1 **Comment #39 D2.1**

2 **(TDL for comments #214 , #248, #304, #239 and #195 from D2.0)**

3  
4 **From TDL List for comment #214 response and remedy + new issues:**

**Figure 33-48—PSE power control state diagram**

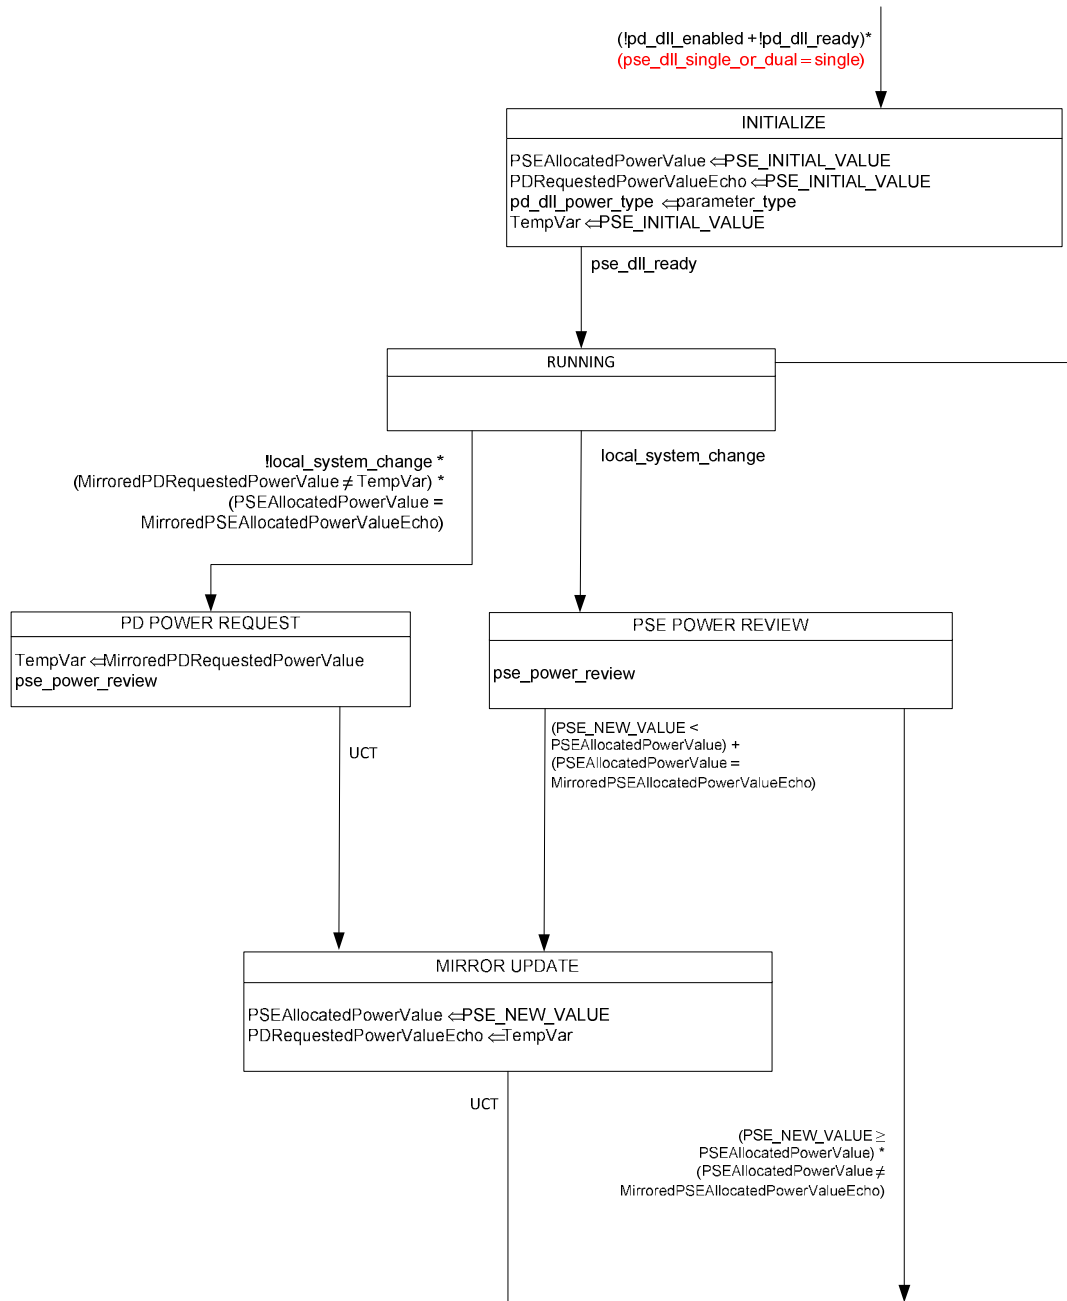
**5. Update the following PSE state diagram Figure 33-48**

Figure 33-49—PD power control state diagram

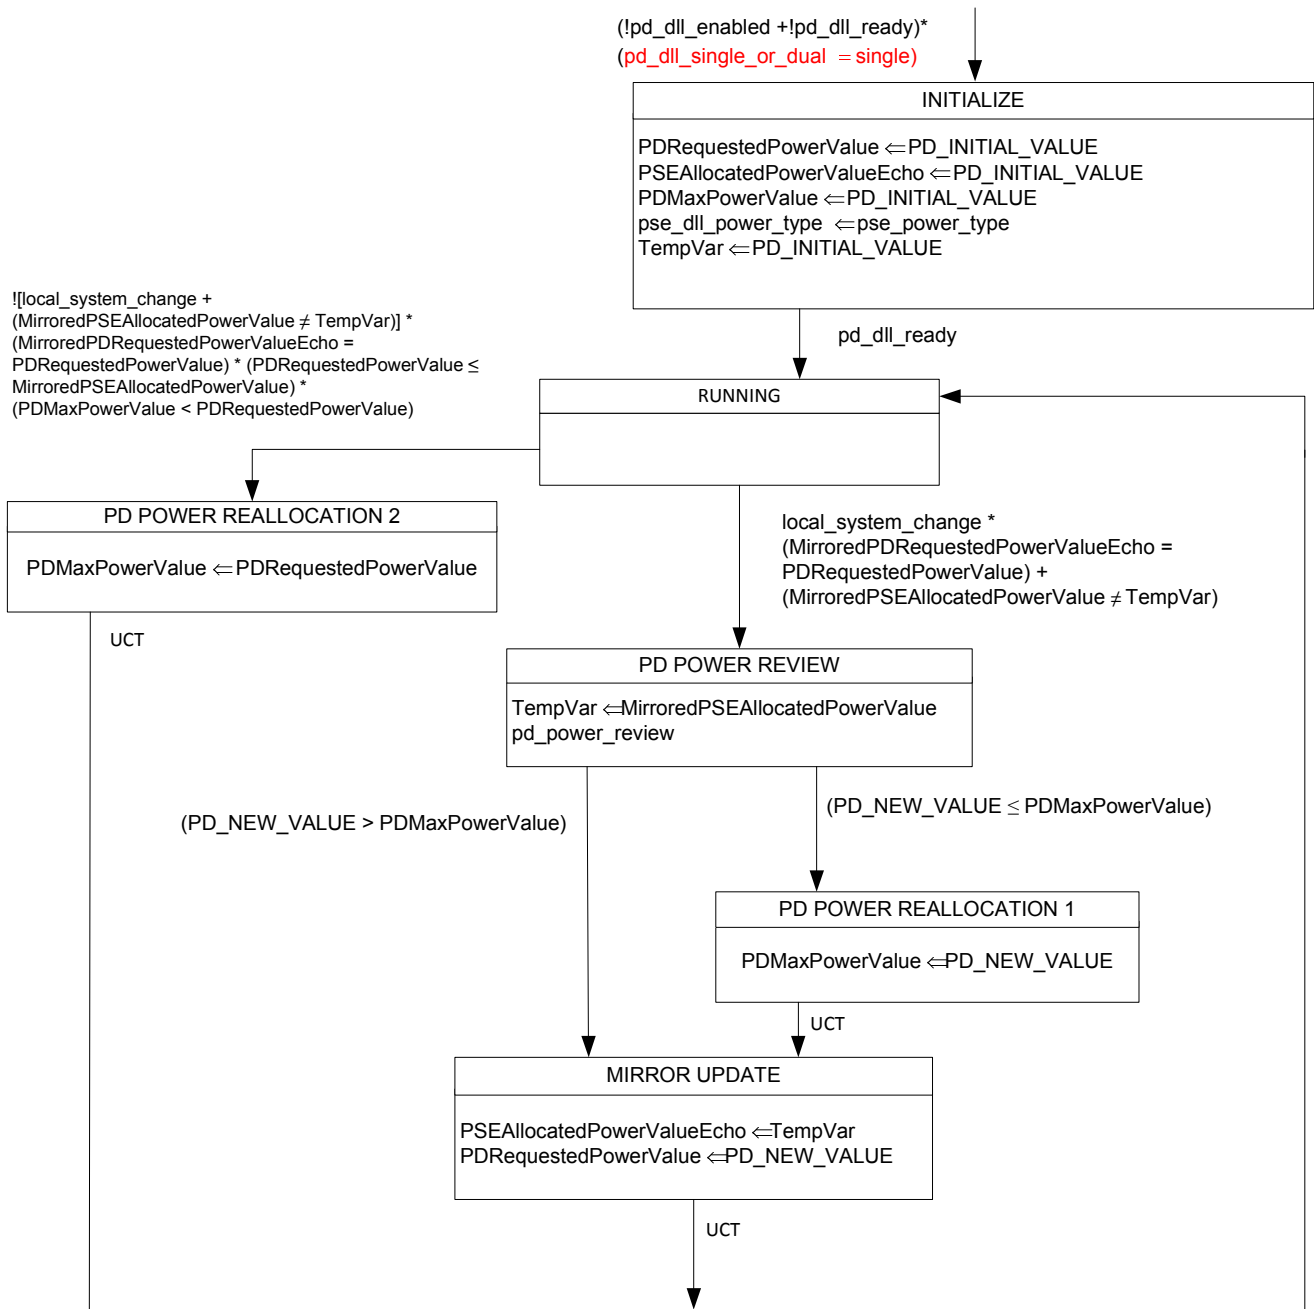
345 **6. Update the following PSE state diagram Figure 33-49**

Figure 33-48A—PSE power control state diagram when connected to dual-signature PD

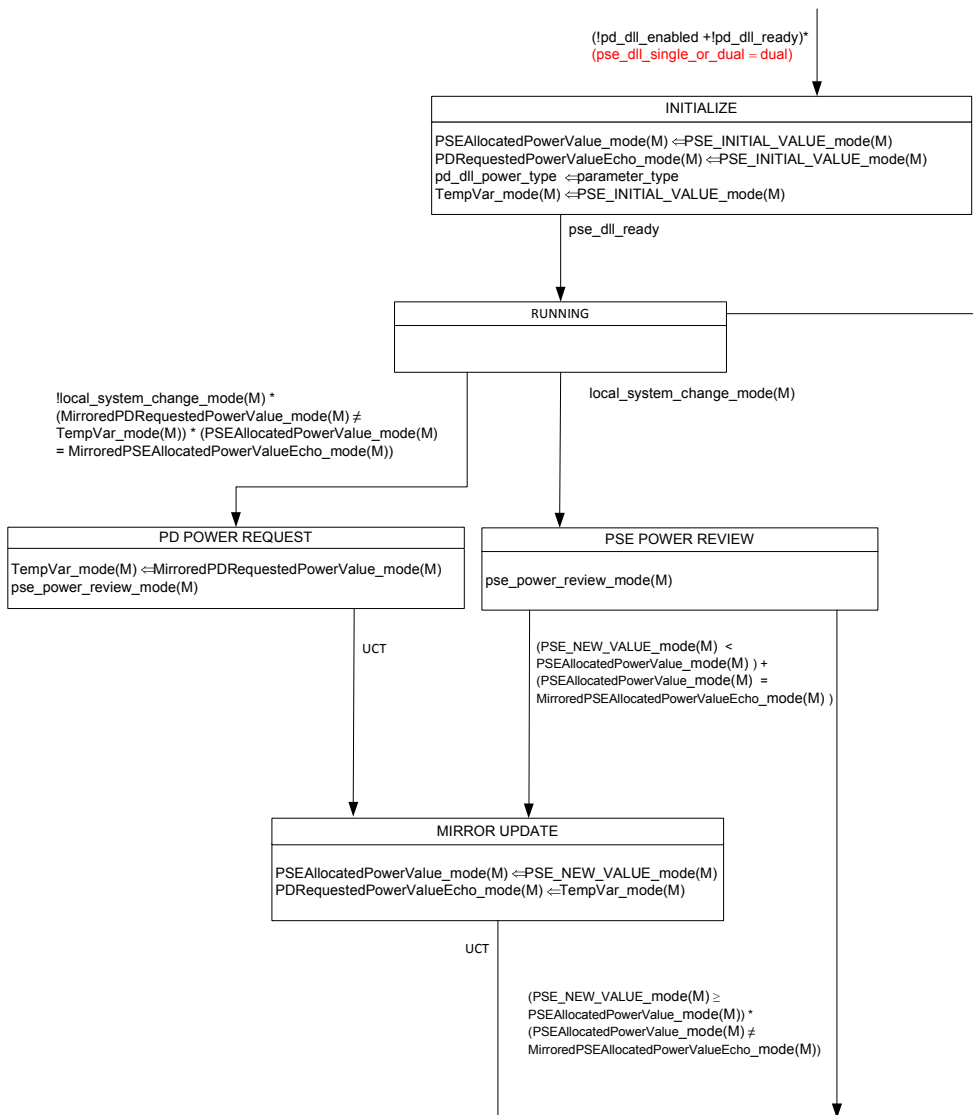
647 **9. Update the following PSE state diagram Figure 33-48a**  
 648 **9.1 Editor to replace all terms with the suffix “\_mode(M)” with the suffix “\_(M)” in Figure 33-48a and**  
 649 **Figure 33-49a.**

650 *(The reason is that some of the variables belong to PSE state machine and some to the PD state machine and the term*  
 651 *“mode” is reserved for the PD.)*

**Figure 33–49A—Dual-signature PD power control state diagram**

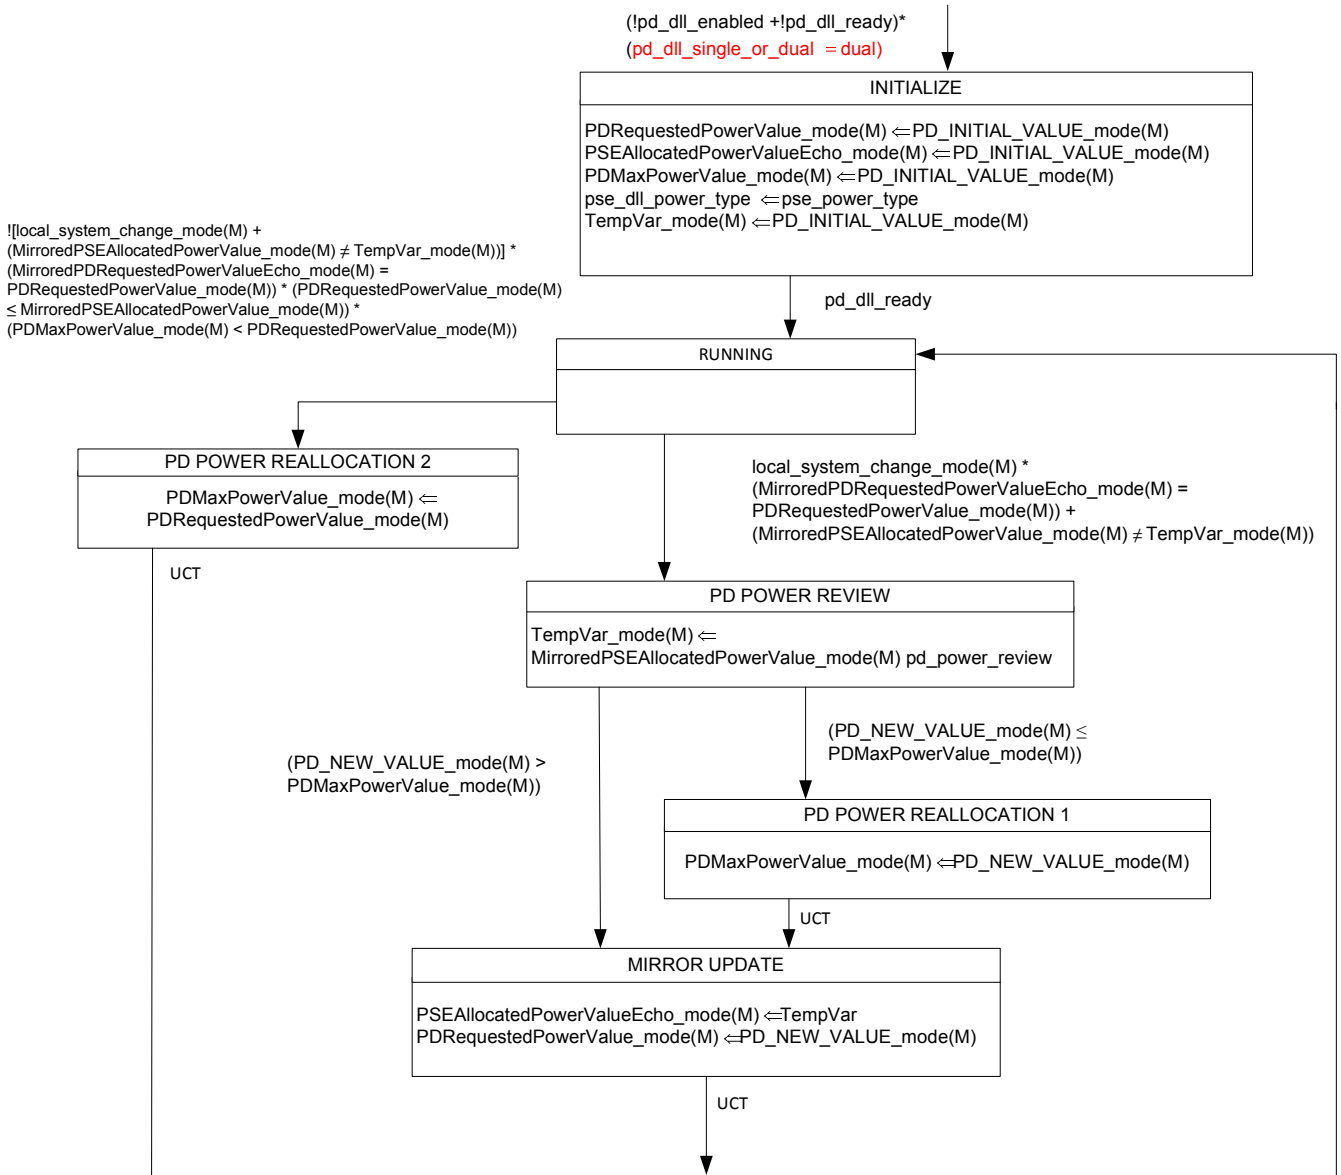
**10. Update the following PSE state diagram Figure 33-49a**

**10.1 Editor to replace all terms with the suffix “\_mode(M)” with the suffix “\_(M)” in Figure 33-48a and Figure 33-49a. (The reason is that some of the variables belong to PSE state machine and some to the PD state machine and the term “mode” is reserved for the PD.)**
